Mandatory Product Update/Safety Bulletin - Spider End Users

SER15-013

SC1000/1500 & SC30/40 Overspeed Safety Device - Safety Bulletin

October 23, 2015

(SC1000/SC1500 shown on left. SC30/40 shown on right)

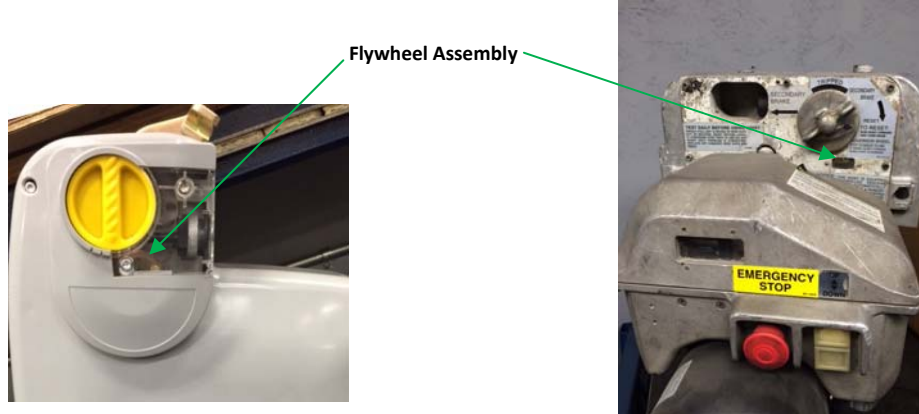
1. As outlined in the Spider Operators Manual (p/n 9961), while powering the hoist "UP" and "Down" approximately 3 feet, look through the window near the Overspeed Brake Test Button to view that the flywheel is rotating. **If the flywheel is not rotating or stops rotating during operation, hoist must be removed from service immediately.**

2. If Flywheel Assembly passes inspection, the hoist may be used for up to 120 days as long as the Daily Test Requirements are performed as outlined in Spider Operators Manual (p/n 9961)
3. If the Flywheel Assembly does not pass inspection, hoist must be removed from service until update has been applied.
